# **EFNA Steering Committee**

## **Meeting Summary**

### **Lacy Road**

### **Fitchburg Community Center to S. Syene Road**

PRELIMINARY PLANS  
FOR DISCUSSION PURPOSES ONLY  
OCTOBER 26, 2015

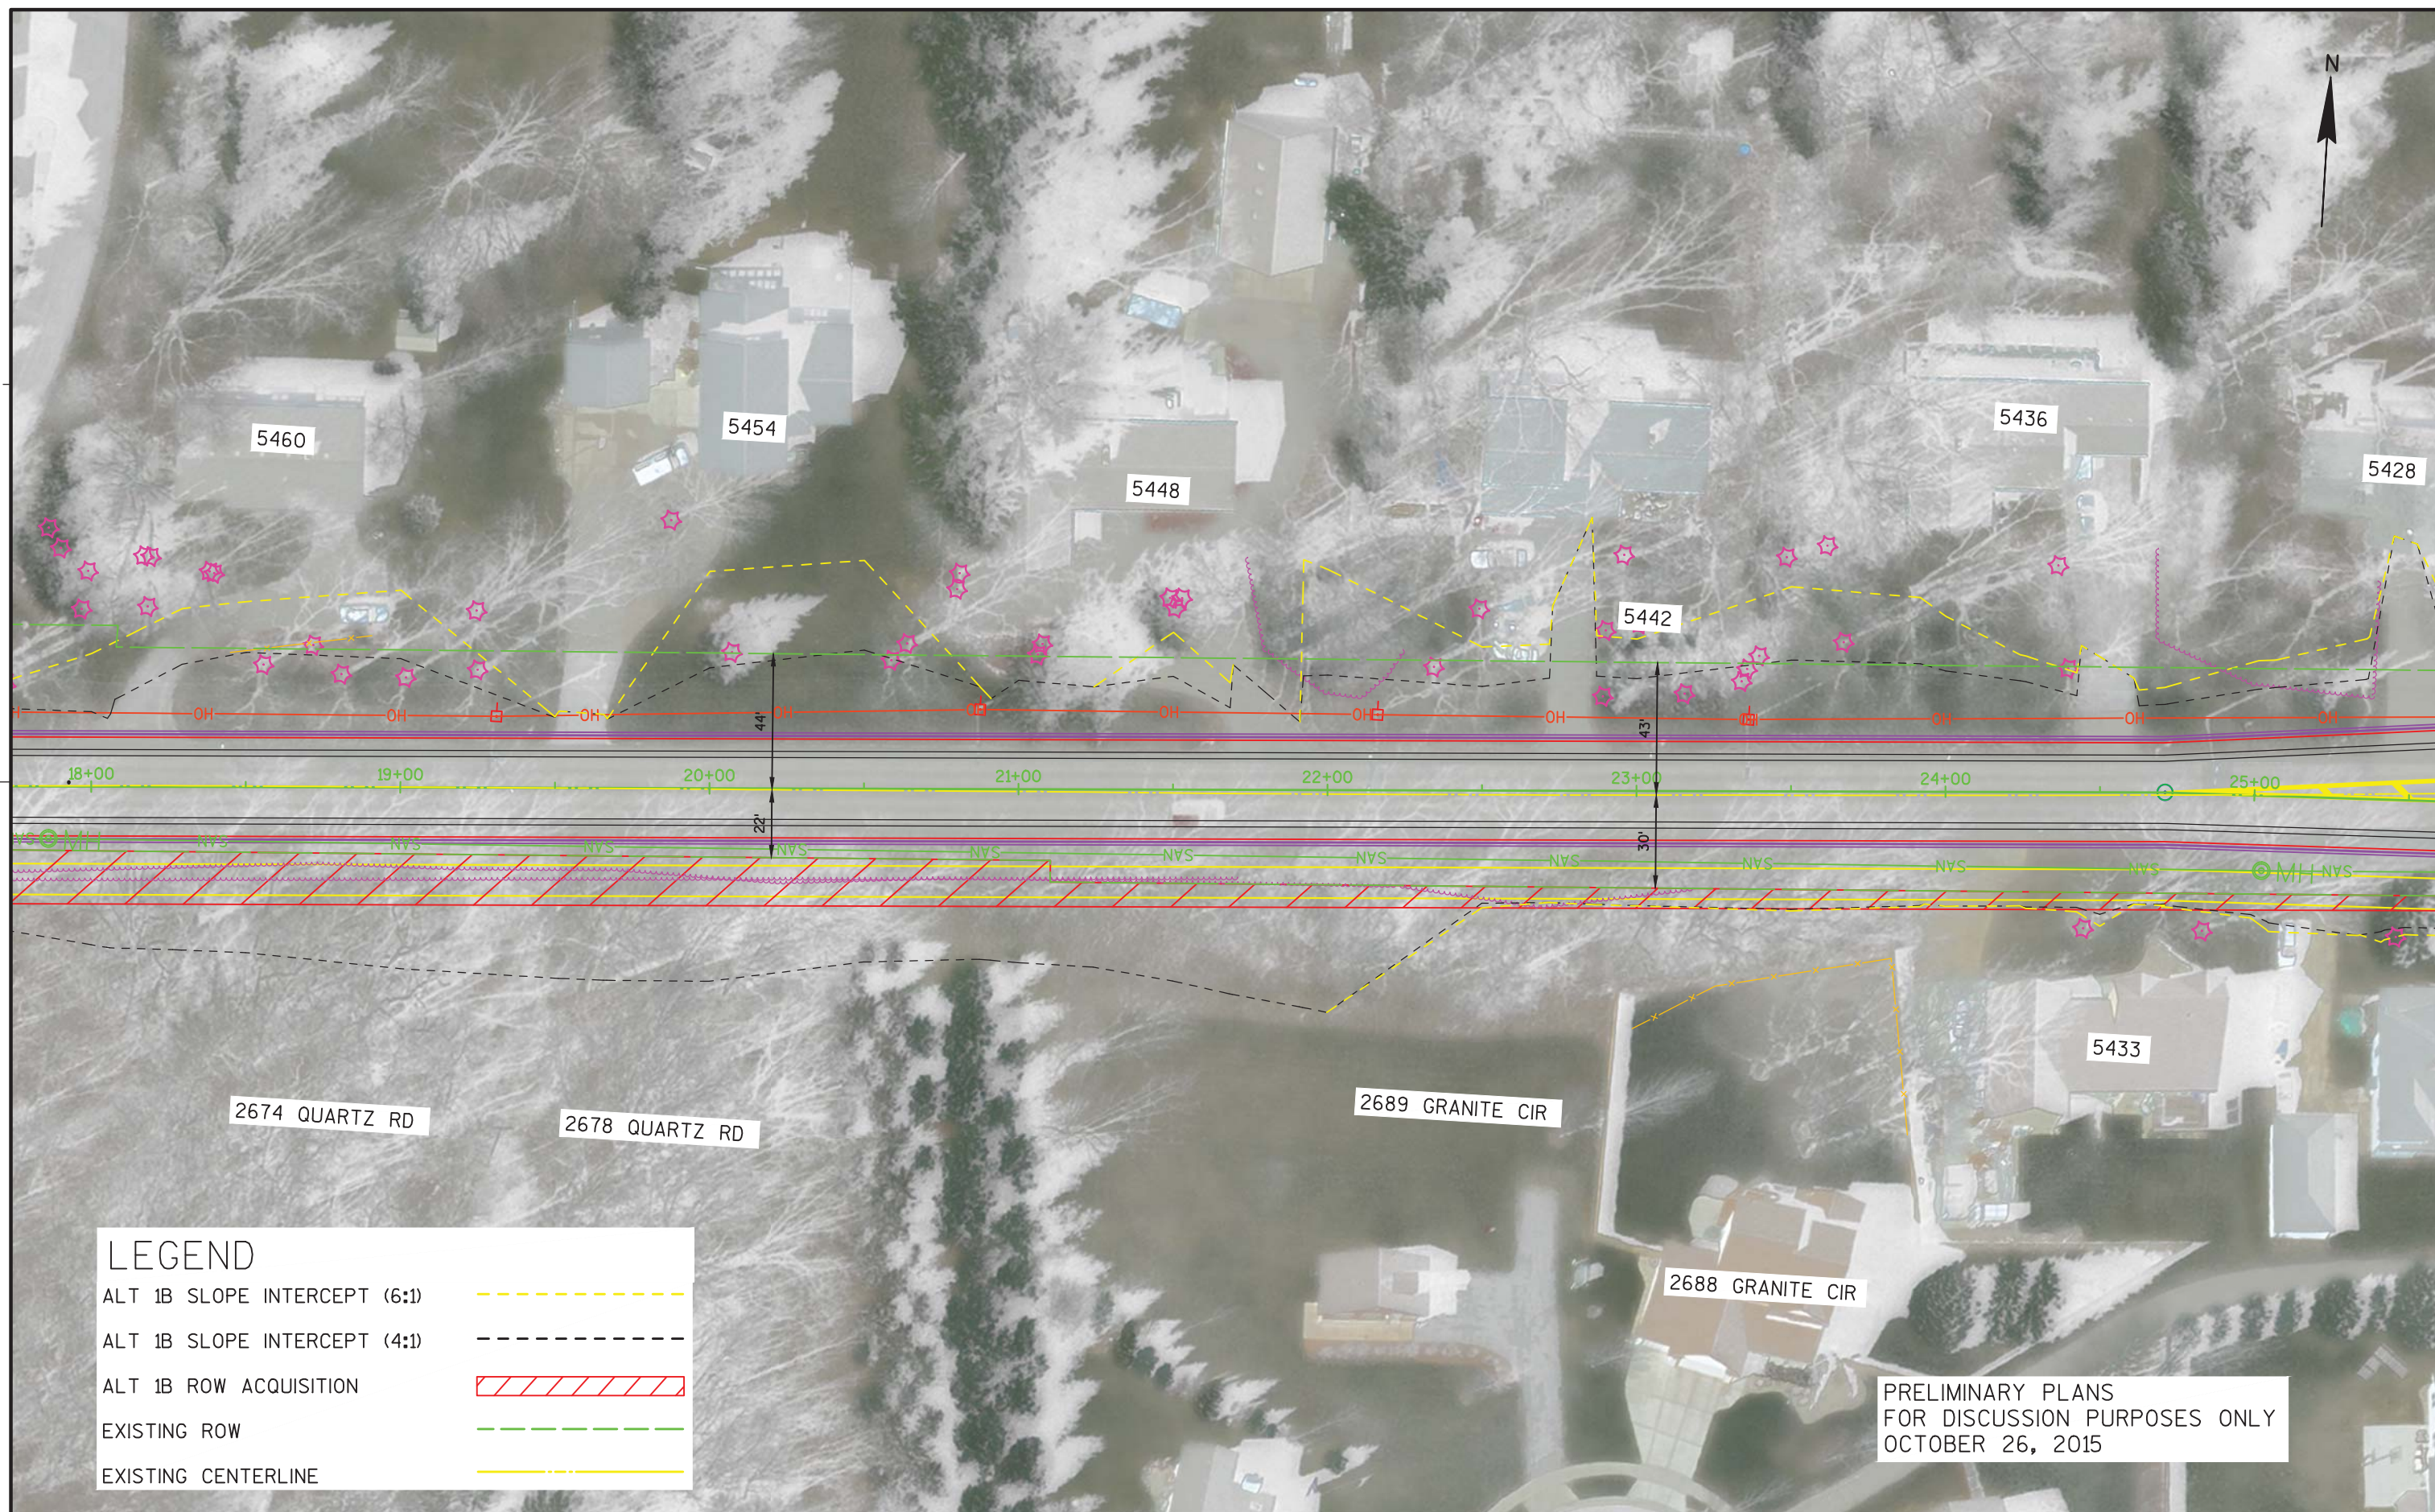
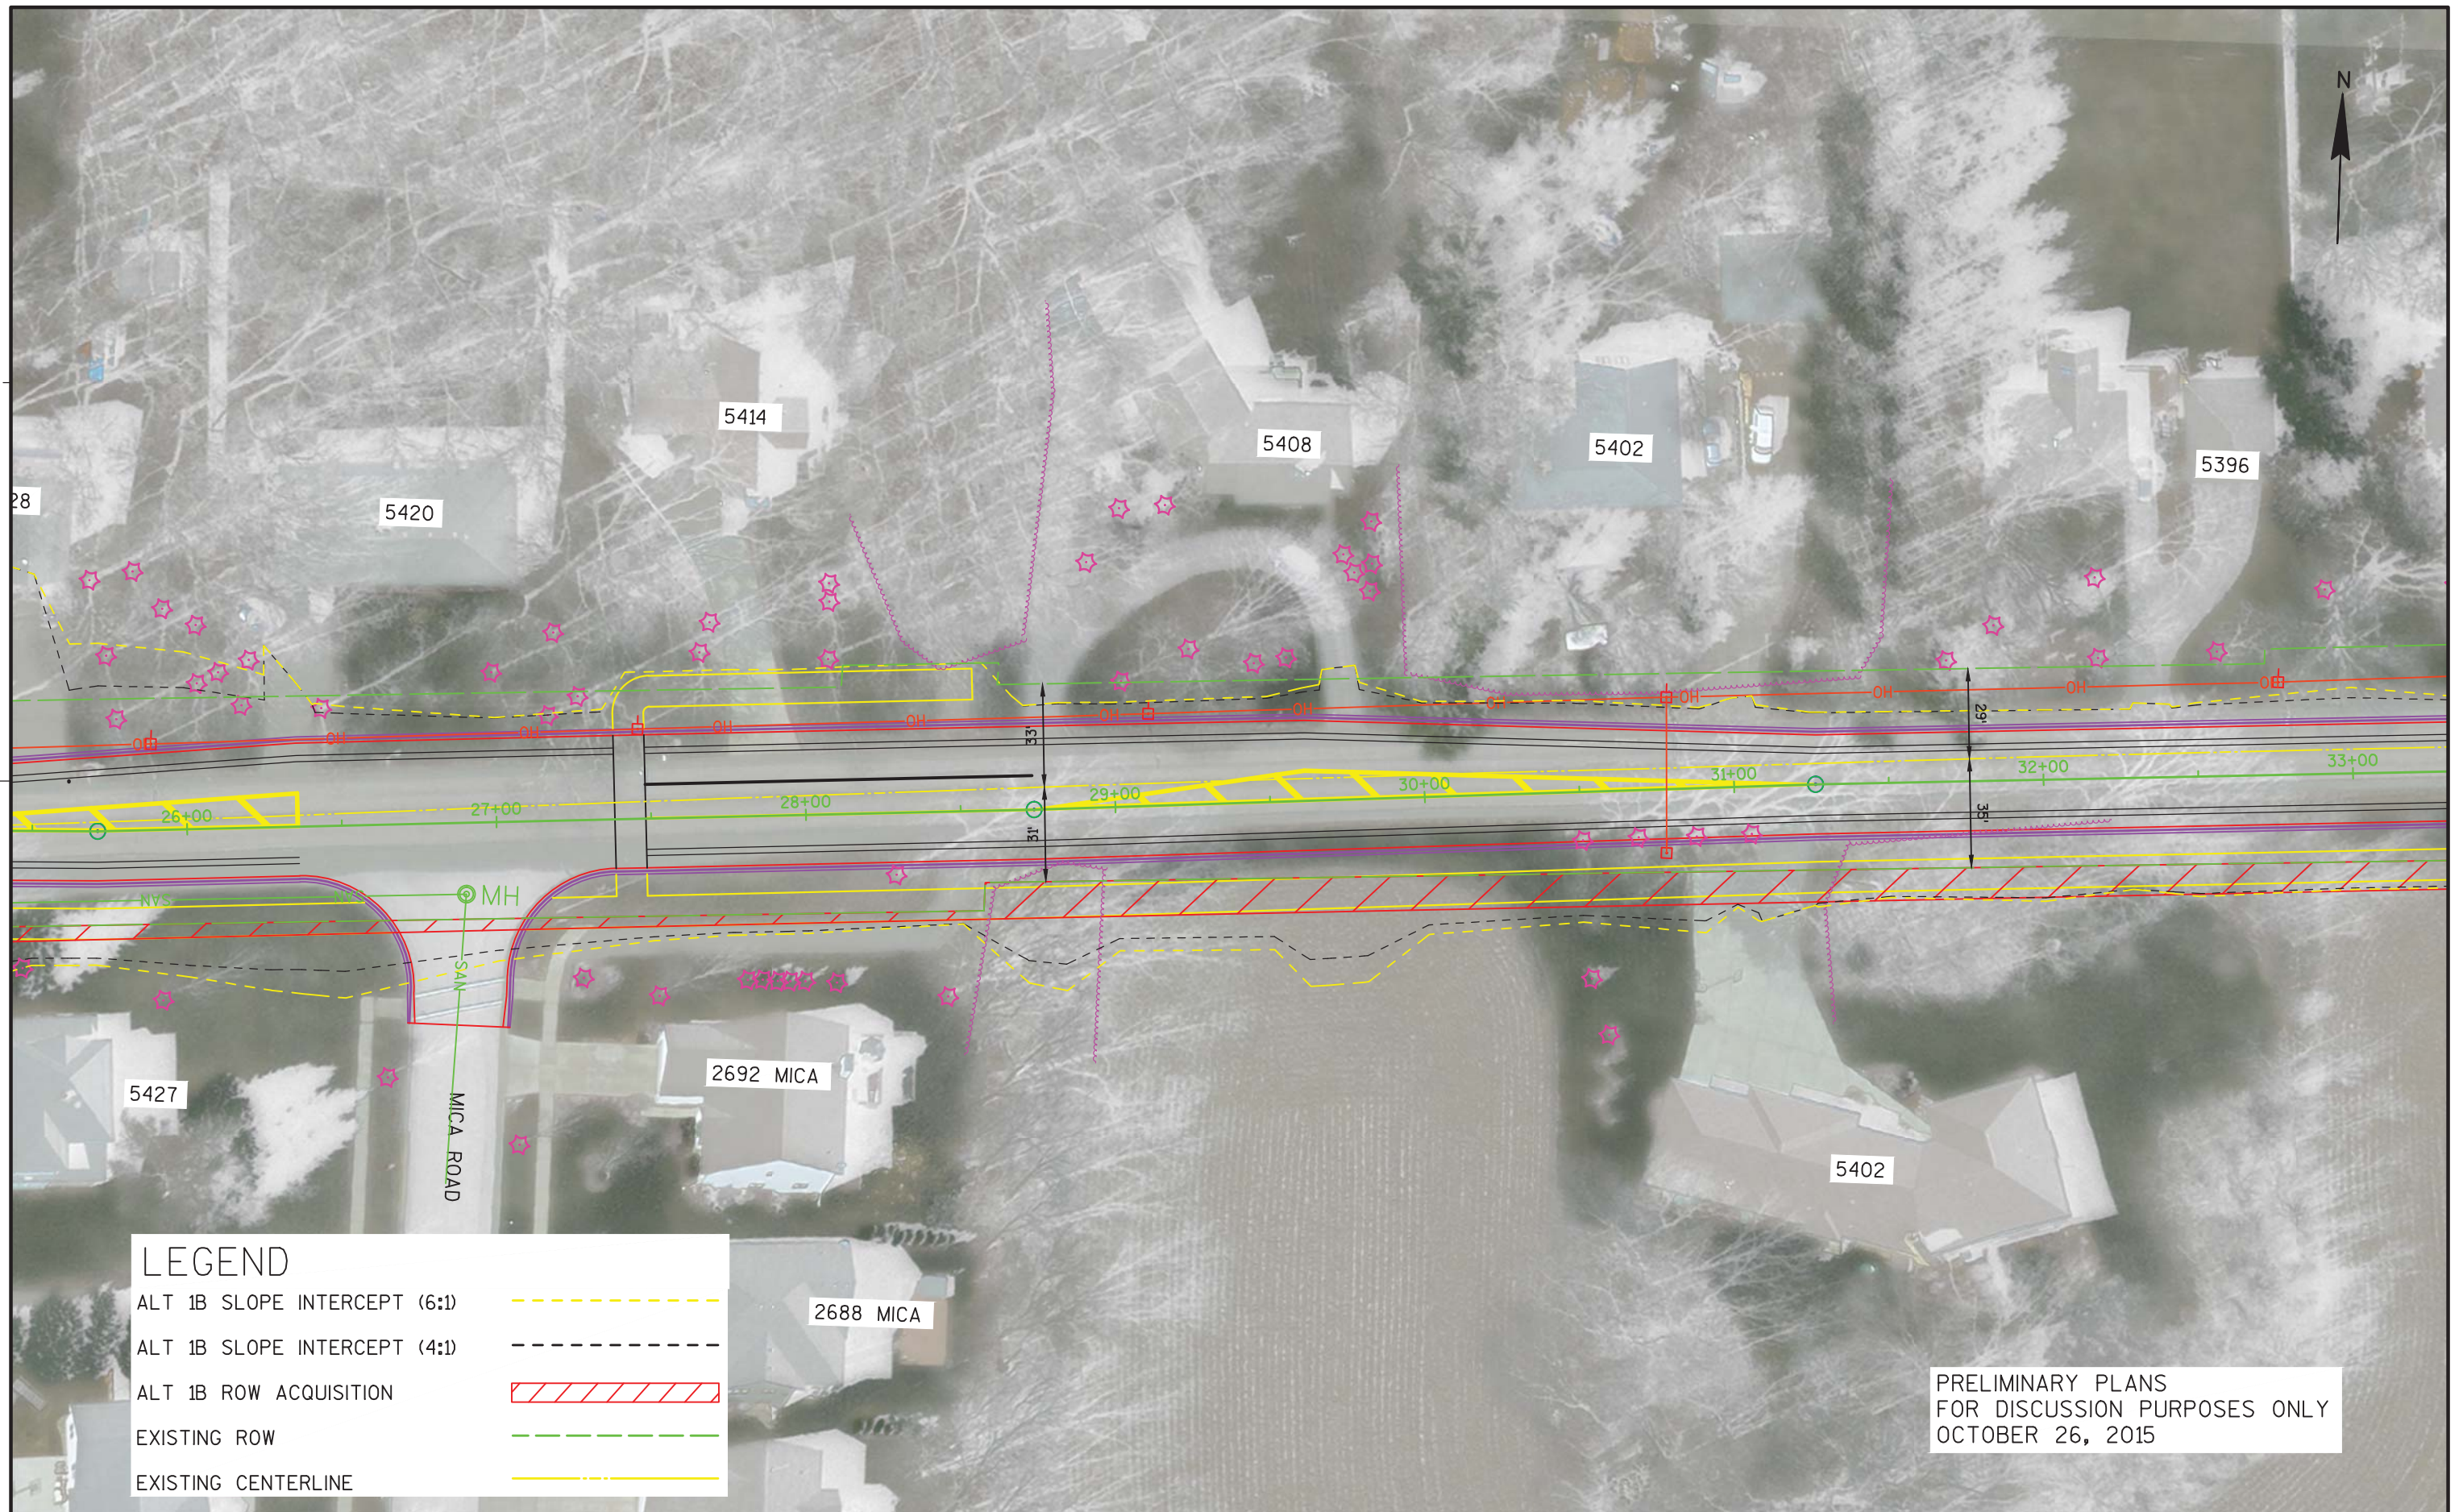
Troy explained that preliminary plans have been prepared from the west project limit east to approximately Waterford Glen. The aerial photos with the proposed linework for the road and path are attached. The initial alignment was established by maintaining the existing road centerline and placing the shared-use path on the south side. Ahna stated that by doing this, it will mean more acquisition on the south side of Lacy Road.

Troy described that the plans show 2 different lines for the slope intercept; one is based on a 6:1 slope and the other a 4:1 slope. Ahna mentioned that the affected homeowners would be contacted to discuss their preference for the slope grades. The 6:1 is less steep, but extends further onto private property to match back in. A 4:1 slope is steeper, but it could avoid impacts to trees or landscaping.

6. Discussion of project impacts – Ahna commented that the initial road alignment (which maintained the existing road centerline) is in conflict with the existing sanitary sewer line. She pointed out that the existing sanitary manholes fall within the proposed curb and gutter. That presents a problem for the manhole structure itself, as well as for the maintenance efforts to clean and repair the sanitary line. The road could be shifted to the south, but that would require even more right-of-way acquisition and would place the sanitary sewer line within the bike lane. Instead, Ahna is recommending the road to be shifted approximately 4' to the north to keep the sanitary sewer line within the 7' terrace between the road and the shared-use path. There was concurrence that it makes sense to shift the proposed alignment to the north to avoid an impact with the sanitary sewer.
